Notice of Intent

Type of Action: APD Change

**Procedure Description:** OXY USA Inc. seeks approval to update approved APDs for the changes below: • Wellhead design change: Cameron MNDS to Cameron ADAPT • Production Casing Special Connection: 5.5" 20# P110 Wedge 461 \*\*Well names for subject wells will change with approval of BLM Sundry submission # 2691157. The sundry has been submitted to the BLM for review/approval, but not yet approved as of this sundry submission. See attached table for well name updates.\*\*

## Dr Pi Fed Unit 17\_8 DA 2BS Bulk Sundry

| CONFIDENTIAL          |                             |                   |                                                                                                                                |                    |                            |  |
|-----------------------|-----------------------------|-------------------|--------------------------------------------------------------------------------------------------------------------------------|--------------------|----------------------------|--|
| MATERIAL & HEAT TREAT | CHECKED BY:<br>D. GOTTUNG   | DATE<br>18 Feb 22 | OXY 13-5/8" 10K ADAPT<br>16" X 10-3/4" X 7-5/8" X 5-1/2"                                                                       |                    |                            |  |

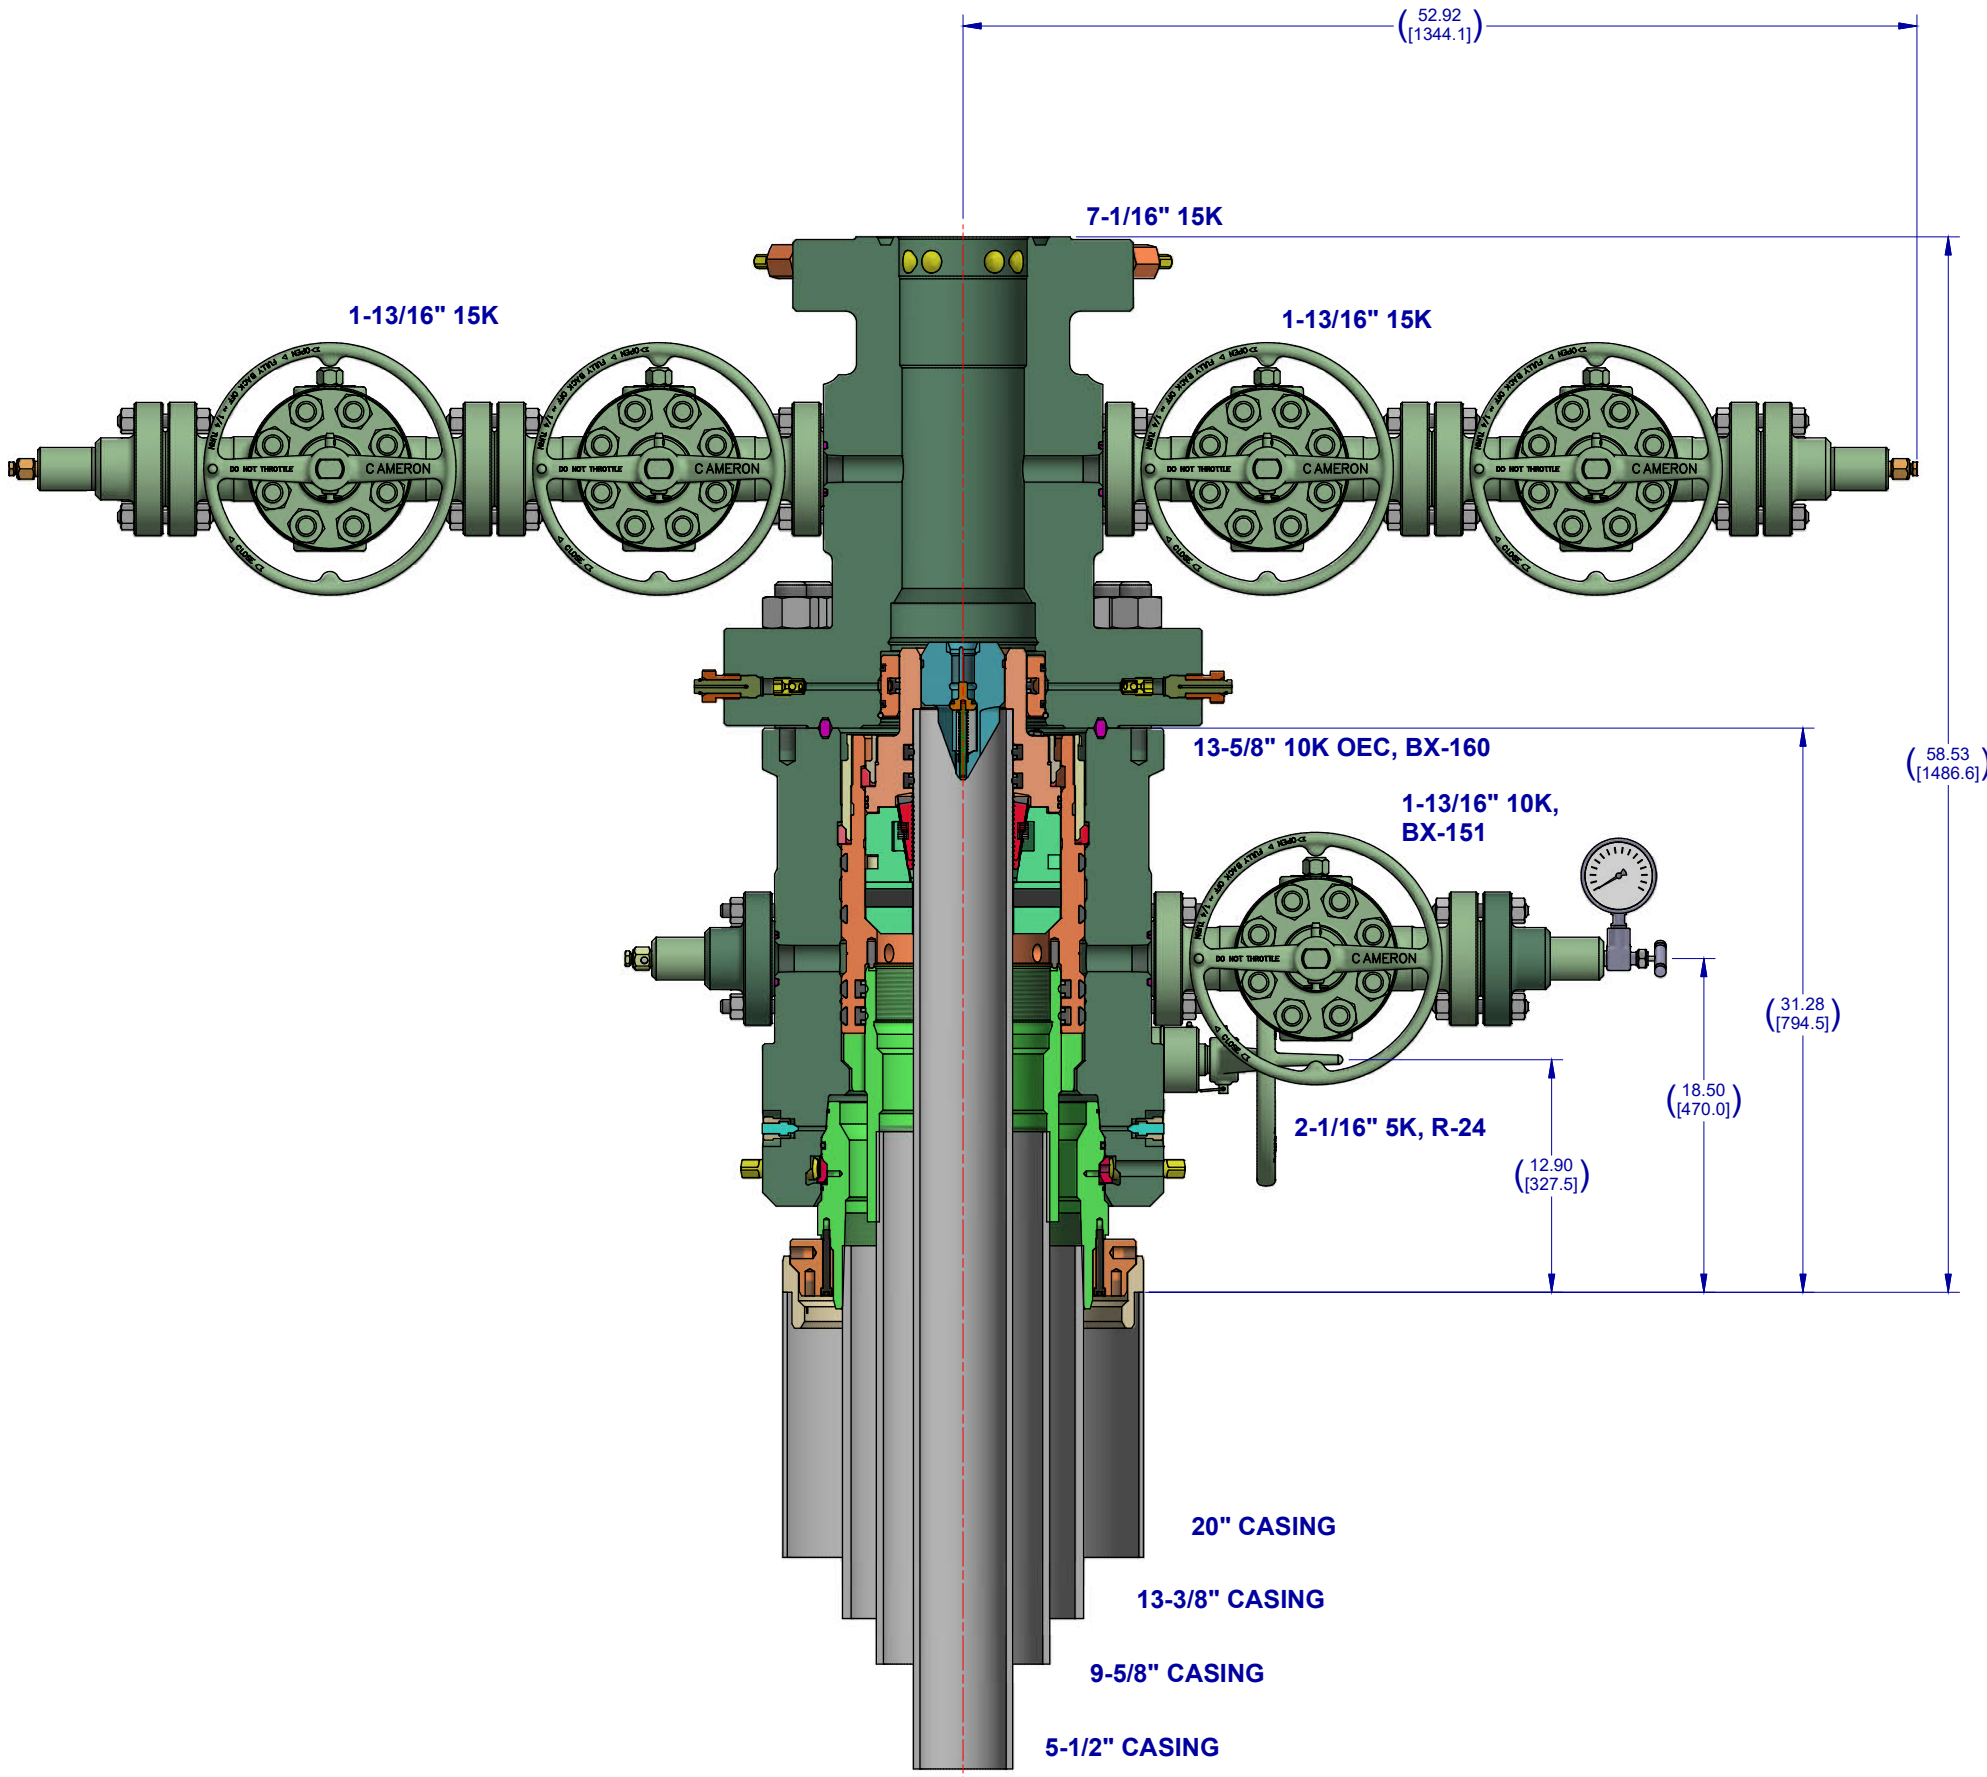
Oxy request to update the following:

- Wellhead design change: Cameron MNDS to Cameron ADAPT
- Production Casing Special Connection: 5.5" 20# P110 Wedge 461
